**Re: El Encuentro Immigrant Community Center
907 4th St. SW
30-Day Temporary Certificate of Occupancy
Transportation Development Final Inspection**
Architect's Stamp dated 01-21-22 (K14-D121)
Certification dated 10-31-22

Re: TCL Certification 907 4th Street SW, Albuquerque
El Encuentro Immigrant Community Center

TRAFFIC CIRCULATION LAYOUT

BICYCLE RACK REQUIREMENTS: 3 BICYCLES
SCALE 1" = 10'

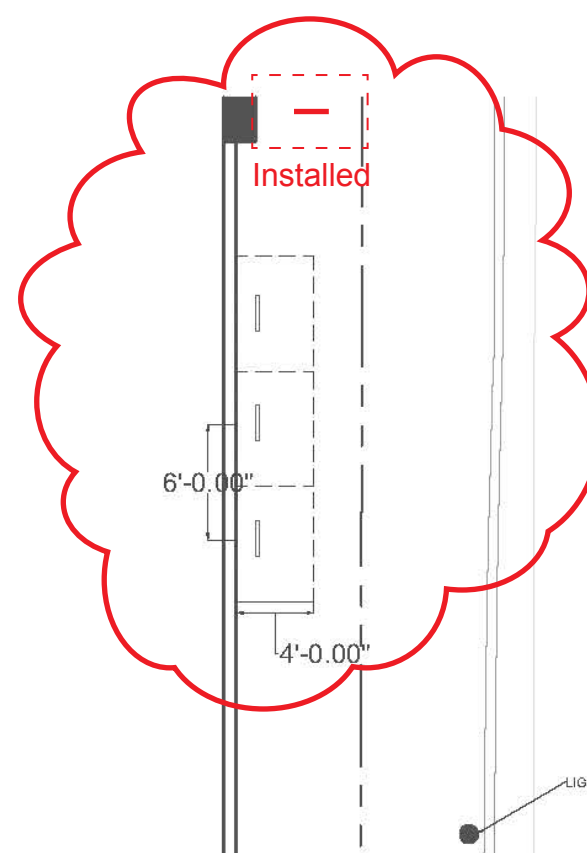
Per the note 11 sheet TCL002 and Bicycle Rack requirements detail on Sheet TCL001, one bicycle loop was installed and not the three as indicated.

11. BICYCLE PARKING
RACK ADDITION
INSTALLED IN ALTERNATIVE
WAY

EXISTING/ PROPOSED CORNER
SCALE 1" = 10'

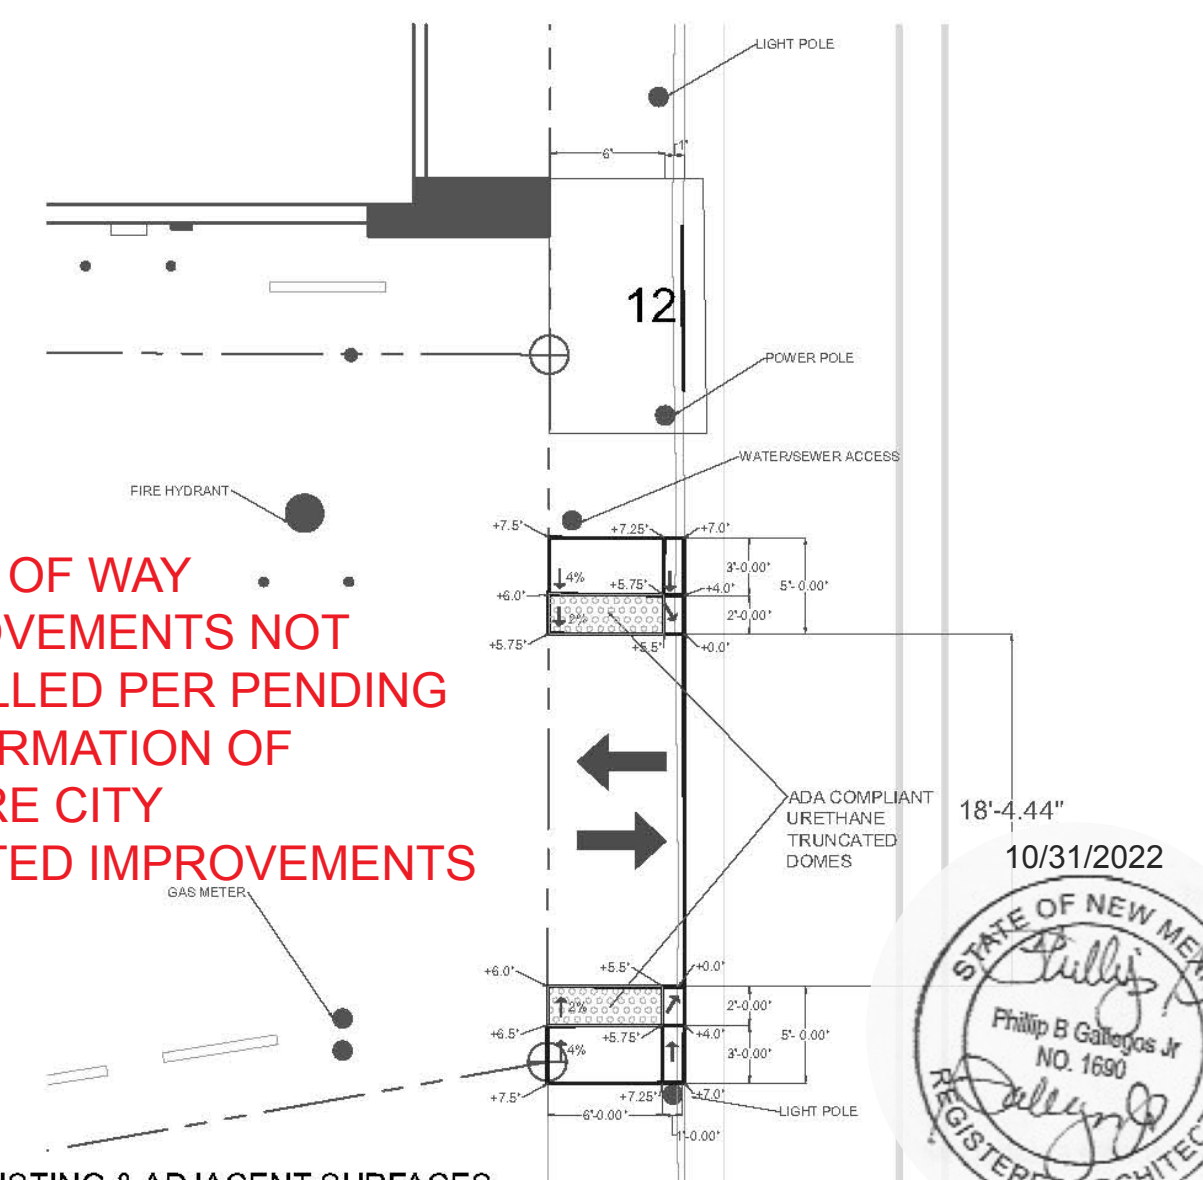
Secondly, we found none of the offsite curb, gutter, and handicapped ramps were not installed per the approved drawing. It is our understanding the City of Albuquerque will be installing street improvements for 4th Street in the near future and therefore these items will be considered in the City project.

RIGHT OF WAY
IMPROVEMENTS NOT
INSTALLED PER PENDING
CONFIRMATION OF
FUTURE CITY
INITIATED IMPROVEMENTS

PROPOSED PARKING & TRAFFIC CIRCULATION LAYOUT
PROPERTY LOT A & B
SCALE 1"= 20'

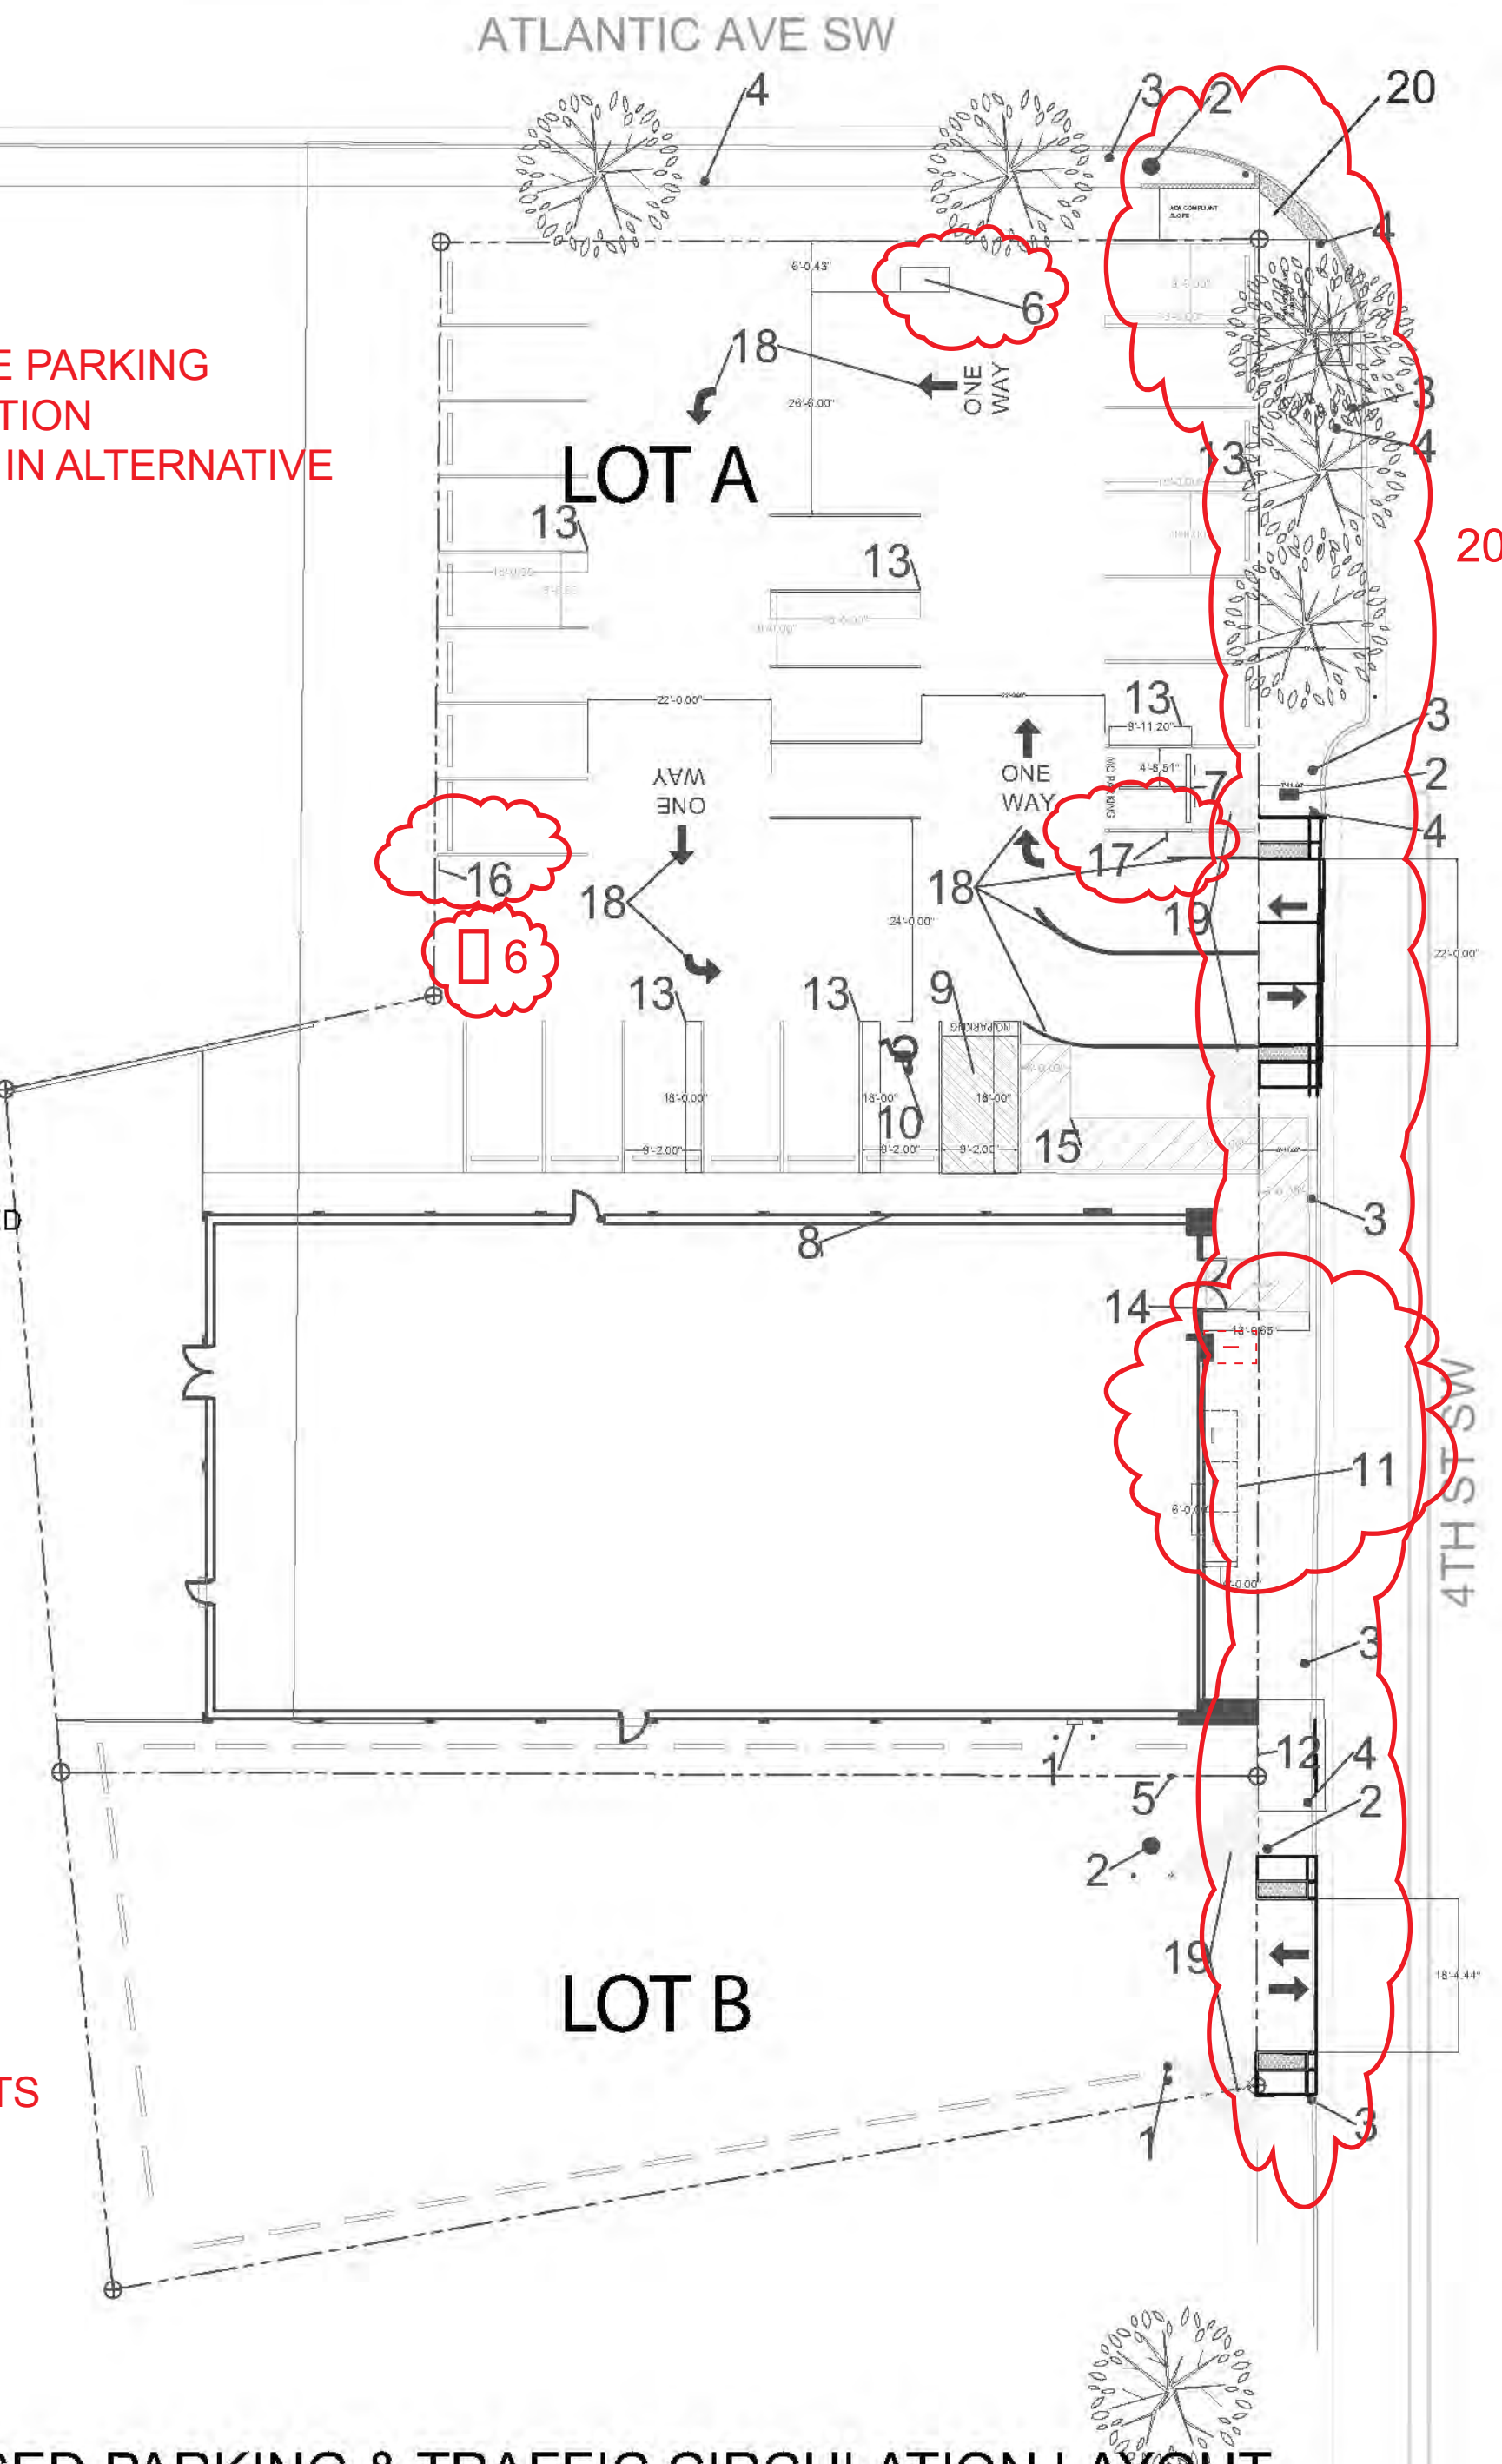
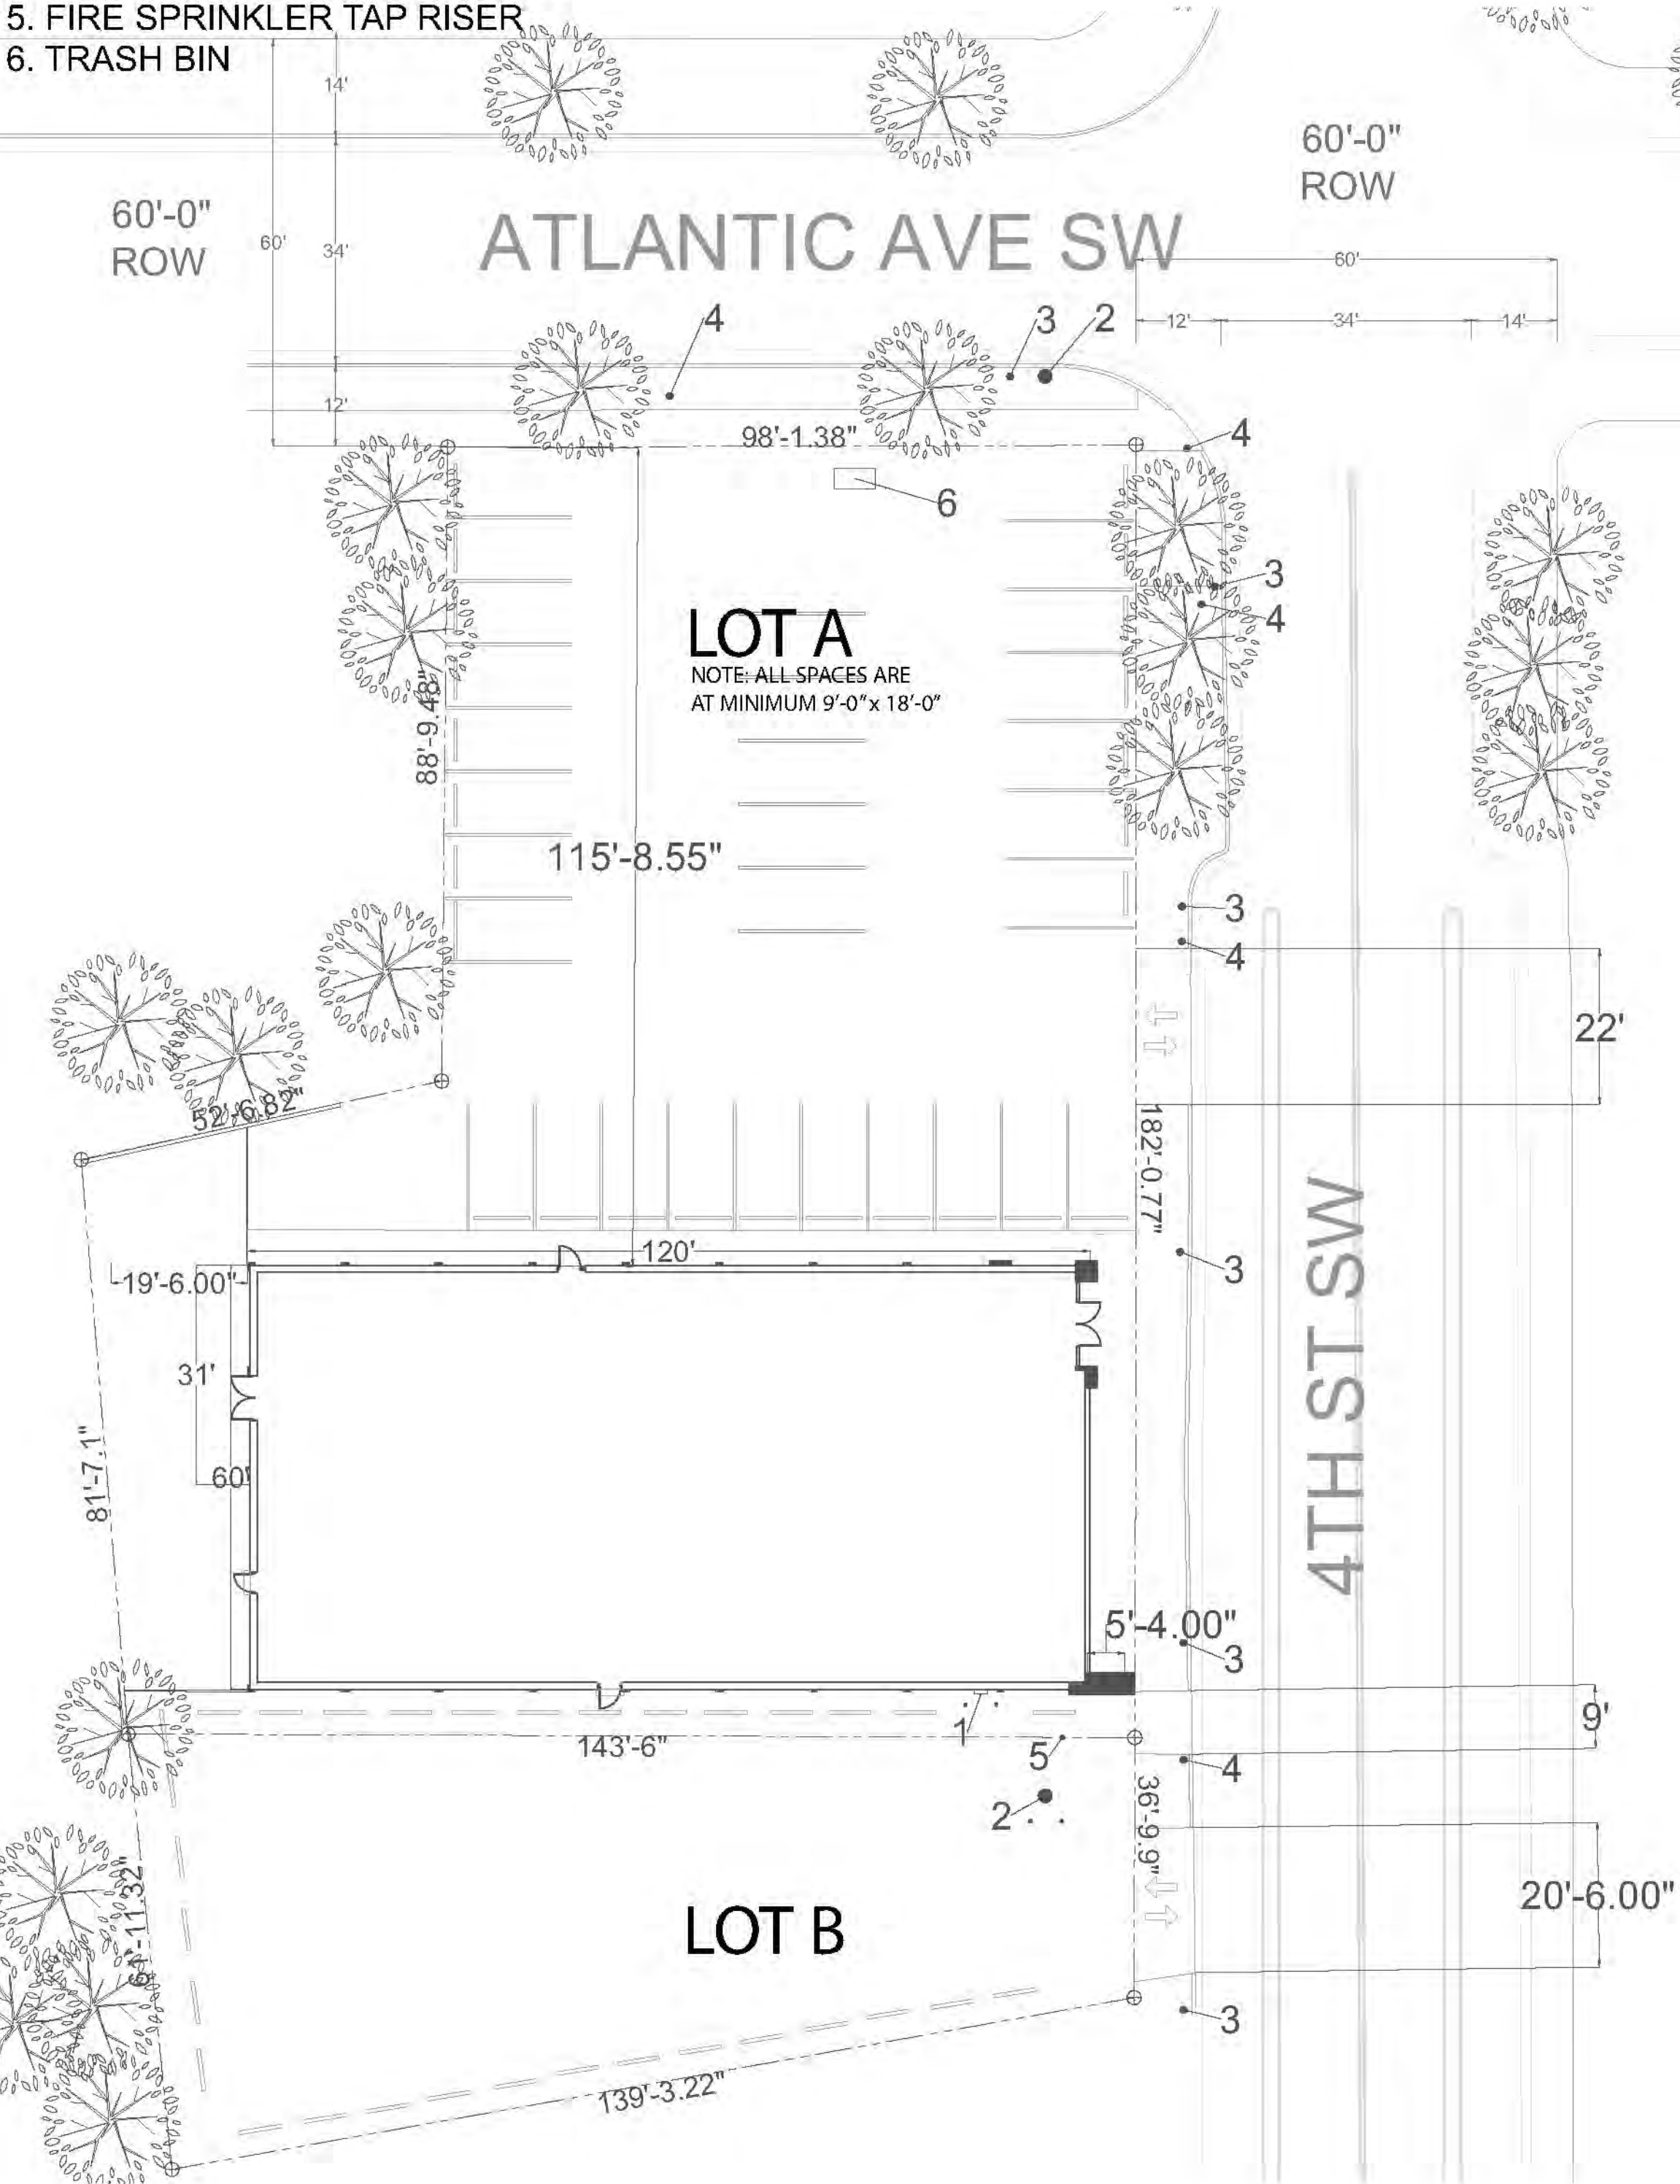
- Please provide City Right of Way improvements project number.
 - The new location of the Trash Bin is blocking one of the parking spaces. Please address this concern.
 - Please provide a written (or email) approval from the Solid Waste department about changing the location of Trash Bin.
 - Per approved site plan key note 9, a 6 ft. wide ADA pathway need to be provided from the ADA aisle to the building entrance.
 - "ONE WAY" and "DO NOT ENTER" signage need to be installed.
- Once these corrections are complete, email pictures to malnajira@cabq.gov for release of Final CO.

Per note 17 and 18 on sheet TCL002 the one way and do not enter sign were not installed.

We contacted the contractor by email, and he has not responded to date. We were contacted by the owner's representative, Ms. Andrea Plaza and she indicated that she had requested permission from the City's Waste Department to relocate the trash bin as they have had neighborhood issues. She will confirm this with a letter if required.

6. TRASH BIN
6. TRASH BIN MOVED WITH WRITTEN
APPROVAL FROM WASTE MANAGEMENT

16. DO NOT ENTER SIGN **16. CHANGE NOT INTSTALLED**

17. ONE WAY SIGN **17. CHANGE NOT INTSTALLED**

20. CORNER DETAIL REFERENCE COA STD DRW 2441.
- 20. RIGHT OF WAY IMPROVEMENTS NOT INSTALLED PER PENDING CONFIRMATION OF FUTURE CITY INITIATED IMPROVEMENTS**
